DESCRIPTIVE REPORT

Registry No. H-11230

Descriptive Report to Accompany Hydrographic Survey H11230

Revisions Compiled During Office Processing and Certification

Figure 2. H11230 Junction Surveys.

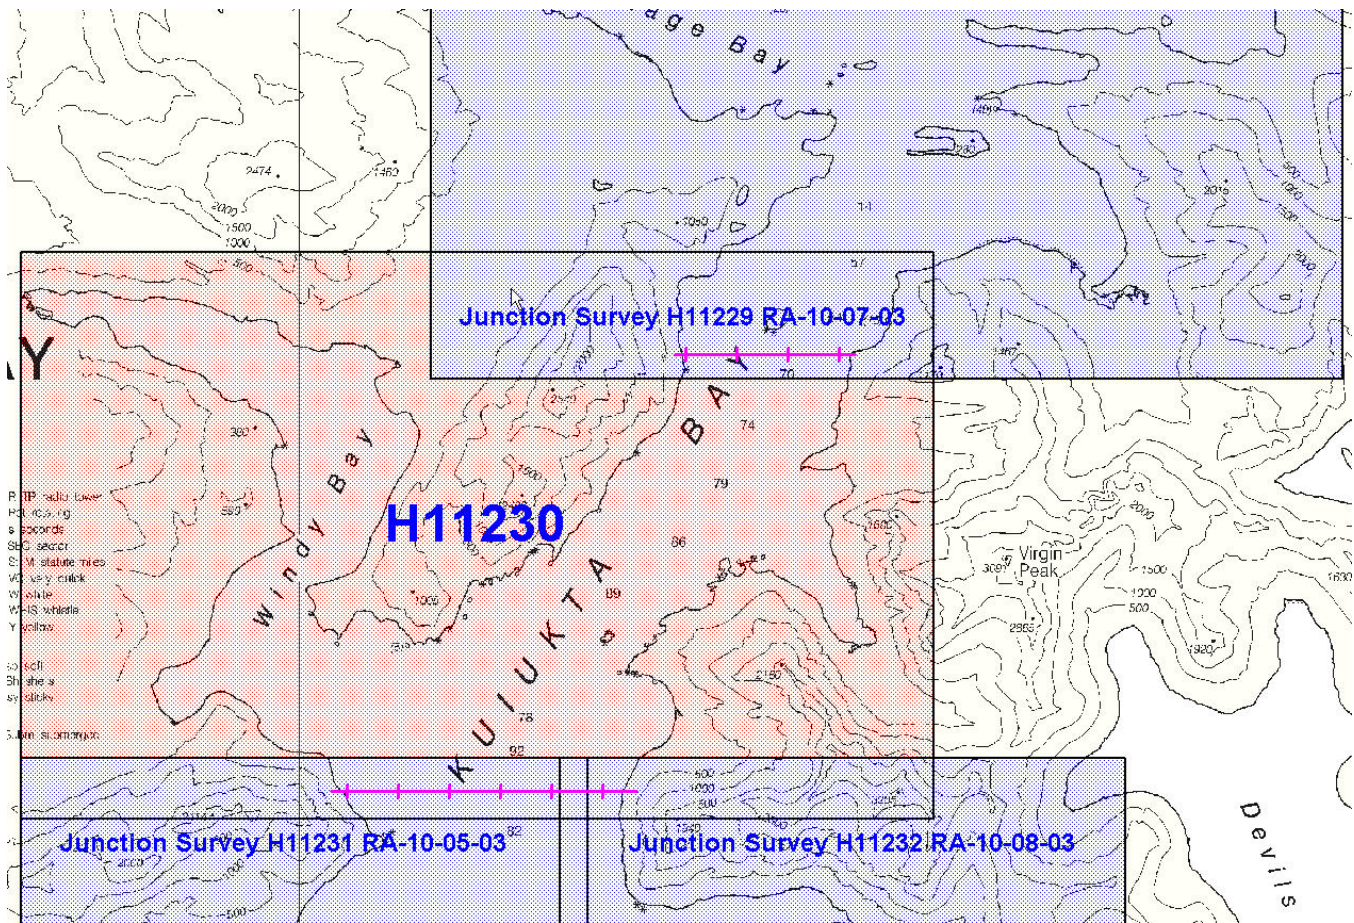
Survey H11229 was not complete at the time of this report; the comparison will be noted in the report for H11229.⁸

Survey H11231 junctions well with this survey. A comparison in CARIS subset mode indicated differences were generally 1m or less in 0-50m of water and 1-3m in water deeper than 50m.⁹

Survey H11232 junctions well with this survey. A comparison in CARIS subset mode indicated differences were generally 0.5m or less in 0-50m of water and 1-2m in water deeper than 50m.¹⁰

- ⁷ Concur.
- ⁸ In PHB processing, H11230 compared well with H11229, generally to within one fathom or less.
- ⁹ Concur.
- ¹⁰ Concur.
- ¹¹ Data analysis during office processing indicates data is consistent and acceptable for charting.
